PLANNING TECHNICAL REVIEW COMMITTEE –AGENDA

PLAN SNAPSHOT REPORT SITE-2024-0012 FOR CITY OF DOVER, N.H.

Subject: Technical Review Committee Response Letter
103 COURT STREET
Dover Tax Map 19 Lot 8
103 Court Street
Dover, New Hampshire
Job No. 24101
City of Dover Planning # Site-2024-0012

At their meeting on August 29, 2024 the Dover Technical Review Committee (TRC) offered the following comments. Our response to each of their comments are identified in blue text.

SP-5

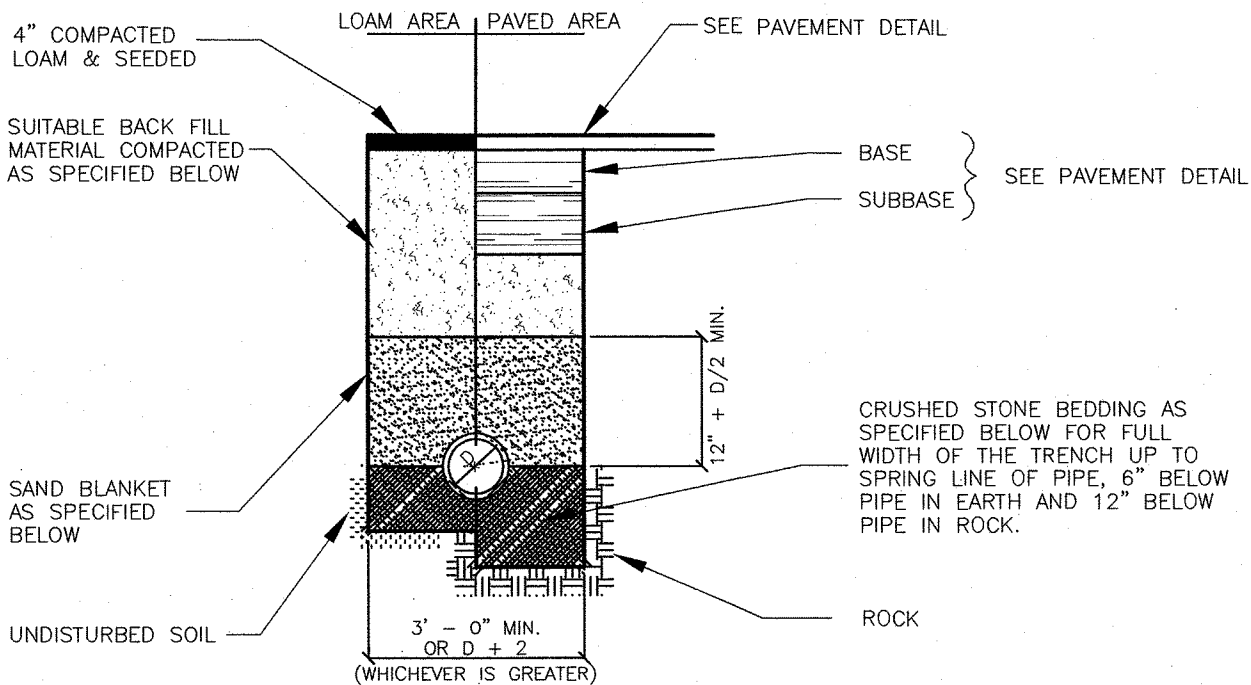
- Sheet SP-5:
 - Please confirm if the intent of the design is to have the bioretention soil mix up the side slopes of the basin. It seems excessive and could potentially wash out into the basin.
The limits of the exposed bioretention "Soil Mix" have been revised to the limits of the basin bottom.

② DOVER STD. D-14 FIRE HYDRANT
NOT TO SCALE

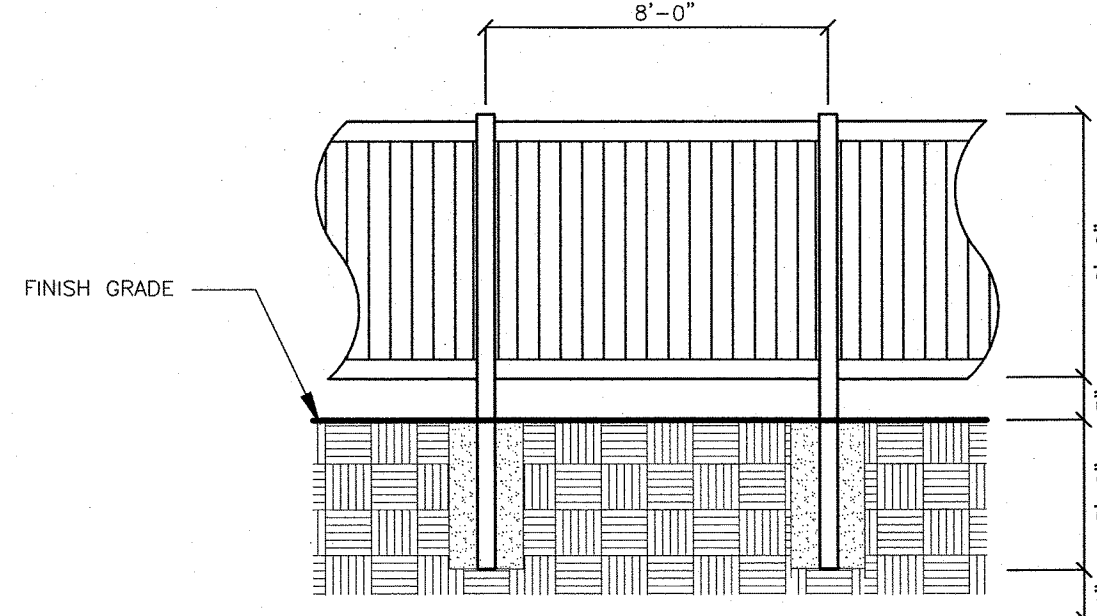
- Fire truck detail is appropriate.
- Fire hydrant to be installed at end of road.

③ VINYL STOCKADE FENCE DETAIL
NOT TO SCALE

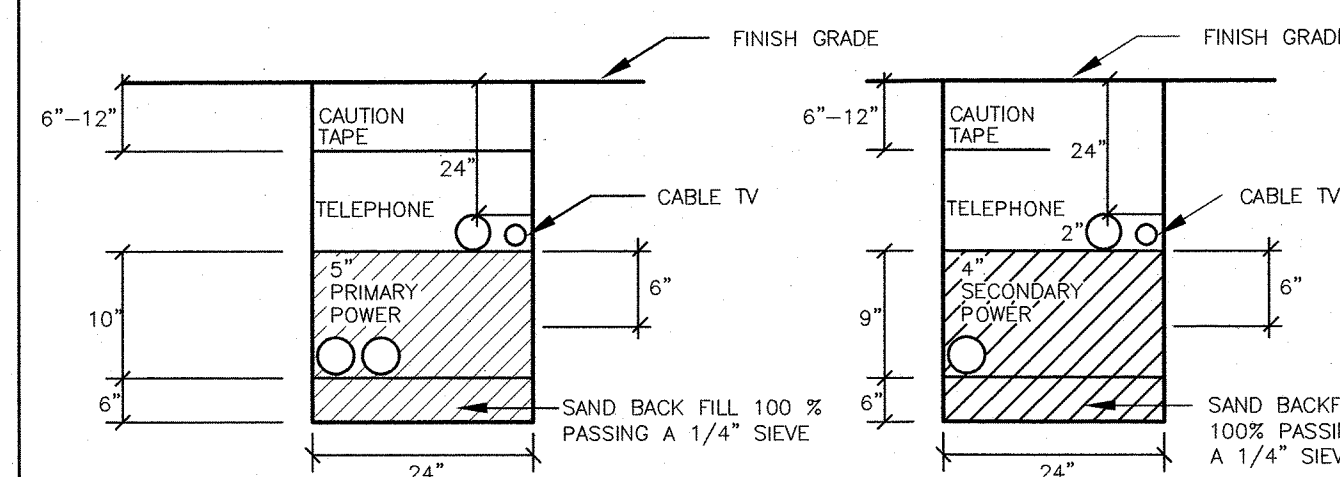
- Provide detail for fencing shown on the landscape plan behind cottage units 3 & 4
- Any additional screening planned behind cottage units?
- Consider moving sewer line

- Provide detail for fencing shown on the landscape plan behind cottage units 3 & 4.
The location of proposed fencing for screening has been adjusted on the plan set. A construction detail for the fence is shown as Detail #3 on Sheet SP-10.

- Any additional screening planned behind cottage units?
The abutters behind the cottages have an existing stockade fence in good condition. We have proposed new stockade fence behind cottage Units 3 & 4 to supplement that existing fence.
